From: [Erin Diehm](#)
To: [Burns, Anne M](#)
Subject: 2022-09-15 DRC - Item IV.1 - 747(787) Bancroft Way - Public Comment
Date: Wednesday, September 14, 2022 11:44:53 PM
Attachments: [2022-09-14 DRC Item IV.1 747 787 Bancroft Public Comment on Bird Safety and Uplighting.pdf](#)

Property Address: **747 (787) BANCROFT WAY**

747 Bancroft | Design Review Committee Response 2

MATERIAL PALETTE
GP0.01.04

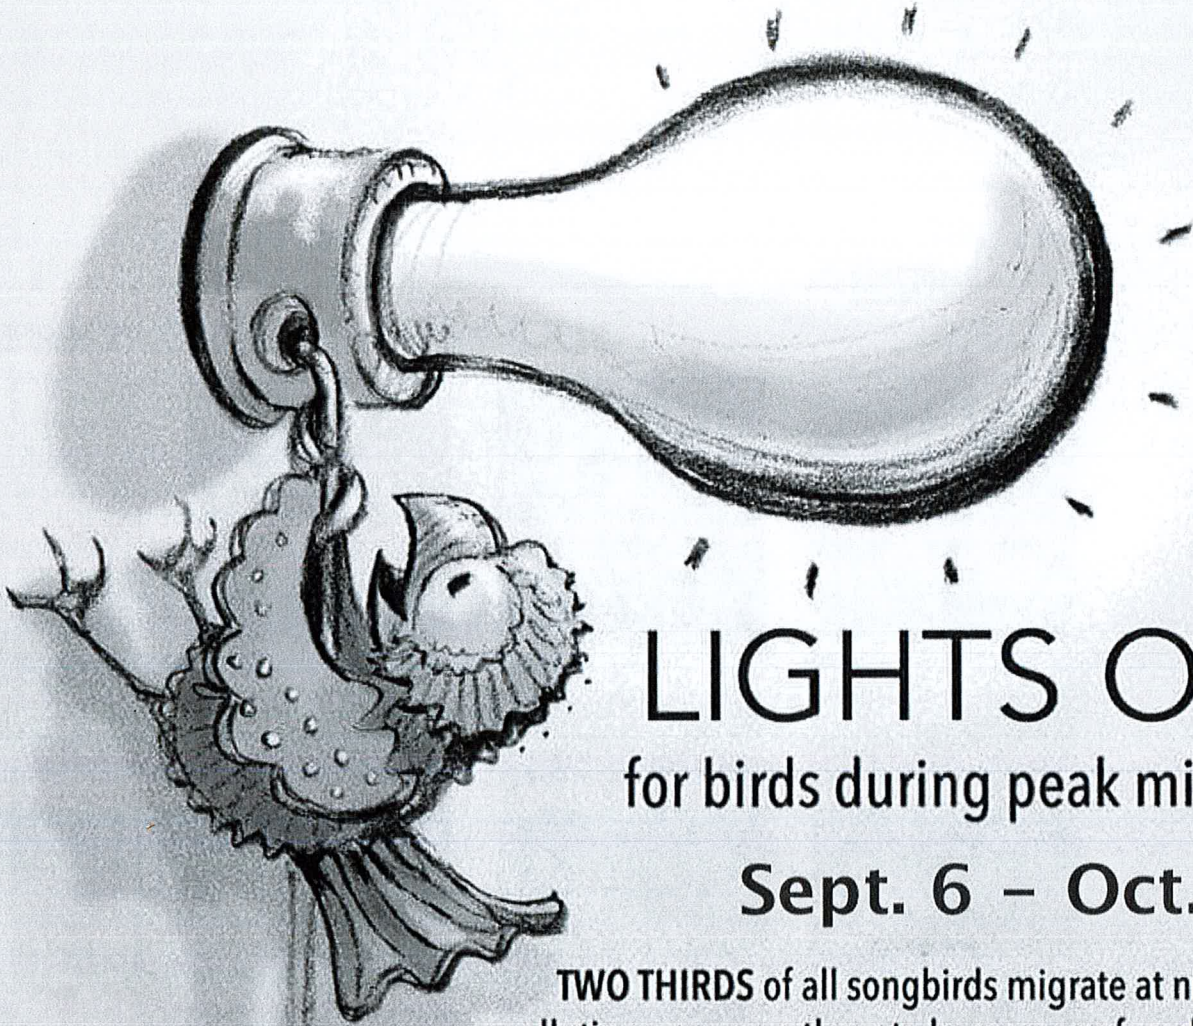
- See page 4 in attached
- The ZAB Use Permit required the applicant to consult with Golden Gate Audubon Society (GGAS) on bird-safety. The latest submittal confirms the meeting with GGAS and seems to state that bird-safe glass will be used on all windows, at all levels.
- **Would it be possible to confirm with the project team that bird-safe glass will, indeed, be used on all windows?** (Very exciting!)

ZAB / Public Works	1	Recommending ZAB require bird safe glazing on all elevations that extend to all floors, or a review from a qualified professional with their recommendations for bird safety.	GP0.01.04	Our glass selection has been revised to have a bird safe frit on all of the glazing on the glass enclosures. Glenn Phillips from Golden Gate Audobon Society consulted our team on best practices for pattern, color, and application. These were applied the glass enclosure on all sides of the building.
	2	Recommend that an amenity space be added adjacent to the North Plaza	L2.01.00 L3.01.02	Confirmed. Refer to landscape Site Plan Sheets for additional amenity space adjacent to the North plaza.
	3	Recommends ZAB require gender neutral bathrooms.		Our project team is still reviewing this recommendation,
	4	DRC recommends permeable pavers in the strips between the street trees. Applicant shall report on Public Works approval at FDR.	L2.05.00	Confirmed with Vincent(PW) for additional permeable pavers used between street tree wells along 4th Street.

GL-1
INSULATED GLASS WITH GRID SAFE CERAMIC FRIT
